SUPPLEMENT 6 TO
APPLICATION FOR LICENSE
UNDER THE ATOMIC ENERGY ACT OF 1954
AS AMENDED

FOR
ALVIN W. VOGTLE NUCLEAR PLANT
UNITS 1, 2

ALVIN W. VOGTLE NUCLEAR PLANT
PRELIMINARY
SAFETY ANALYSIS REPORT

INSTRUCTION SHEET-2
SUPPLEMENT NO. 6

Georgia Power	ALVIN W. VOGTLE NUCLEAR PLANT UNITS 1 AND 2
EQUIPMENT BUILDING PLAN AT FINISH GRADE	
FIGURE 3.8-27

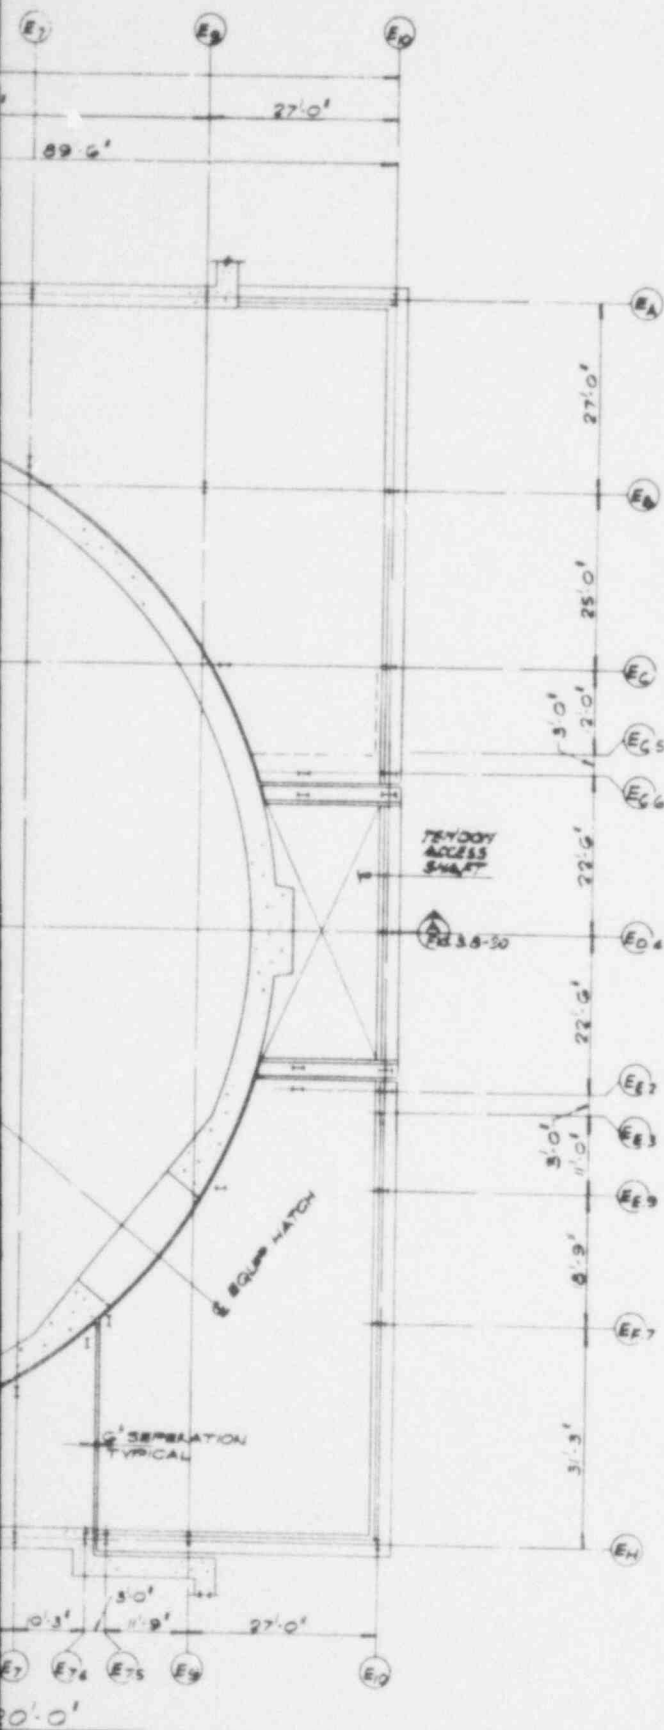
Insert figures 3.8-27 and 3.8-28; insert change sheet for figure 3.8-29 and figures 3.8-30 and 3.8-31 ahead of figure 3.8-27.

<u>Figure</u>	<u>Title</u>		
3.8-27	Equipment Building Plan at Finish Grade	S6	
3.8-28	Equipment Building Roof Framing Plans	S6	
3.8-29	Deleted	S6	S6
3.8-30	Equipment Building Sectional Elevations	S6

Figure 3.8-29

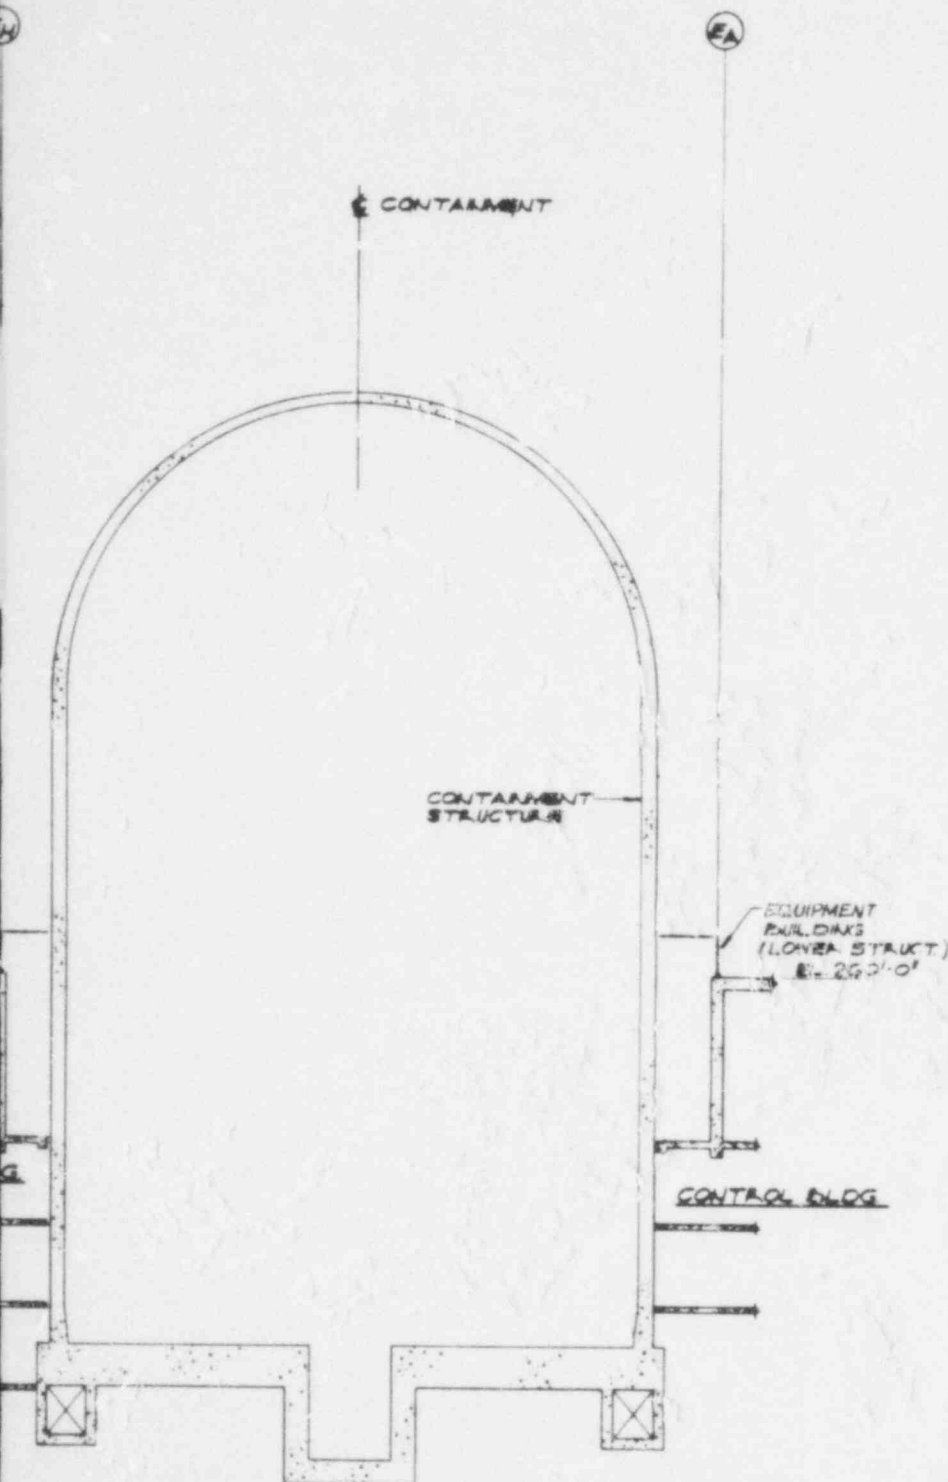
This figure has been deleted by Supplement 6.

Georgia Power	ALVIN W. VOGTLE NUCLEAR PLANT UNITS 1 AND 2
EQUIPMENT BUILDING ELEVATIONS	
FIGURE 3.8-31

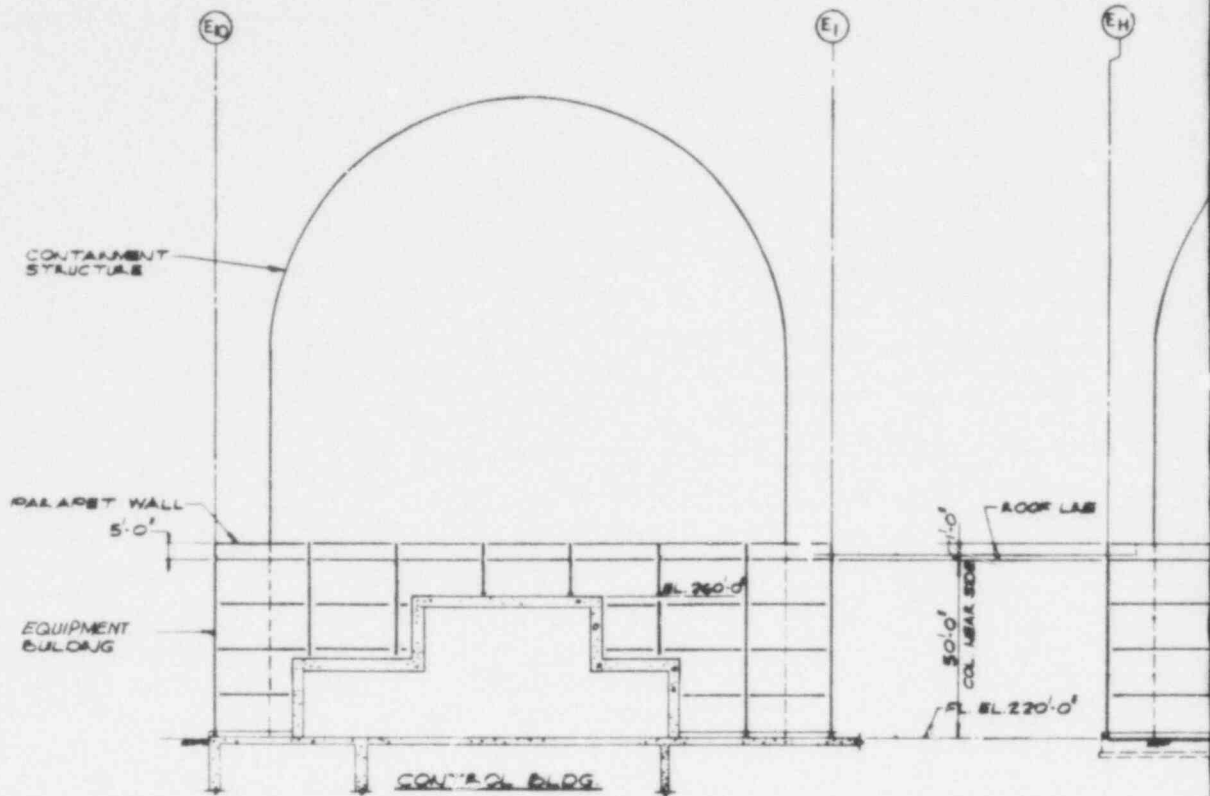
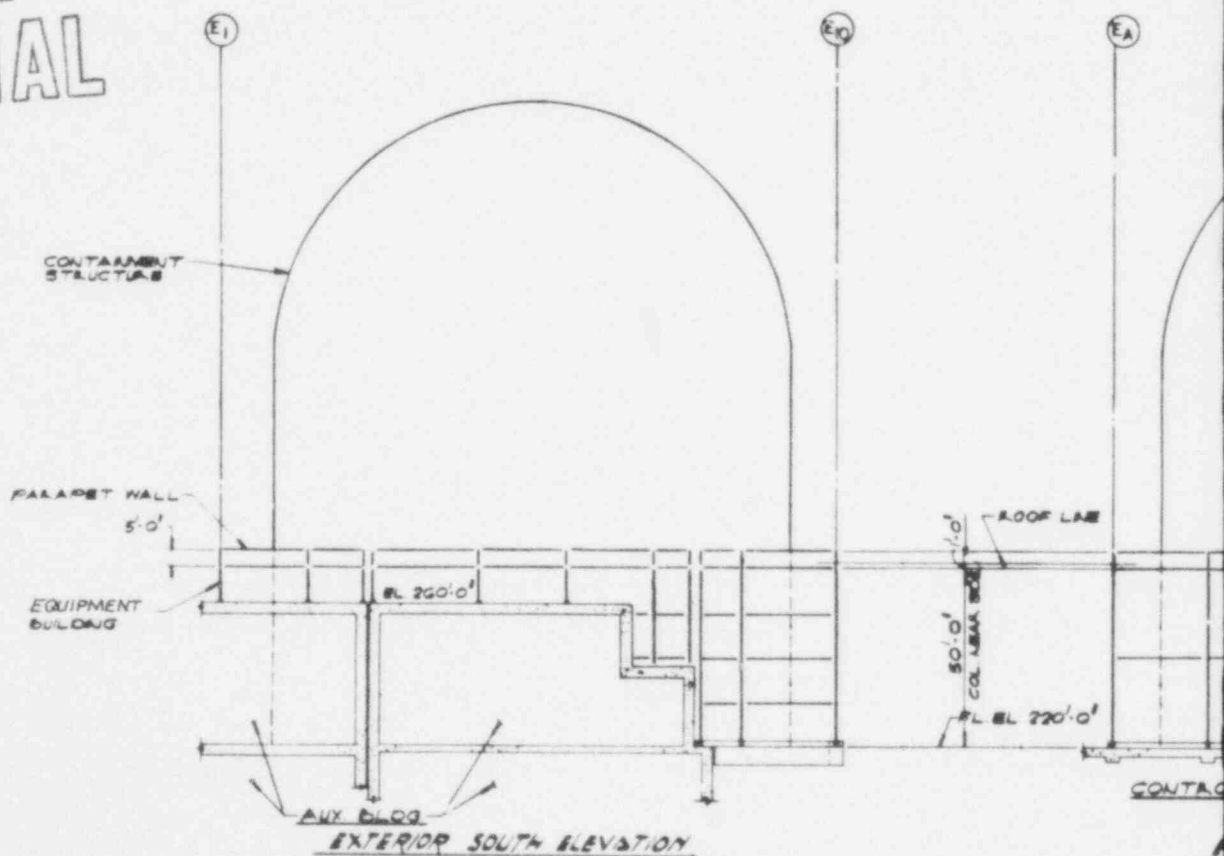
3.8-31	Equipment Building Elevations	S6	
3.8-27	Enclosure Building at Finish Grade		
3.8-28	Enclosure Building Roof Framing Plans		
3.8-29	Enclosure Building Intermediate Horizontal Framing
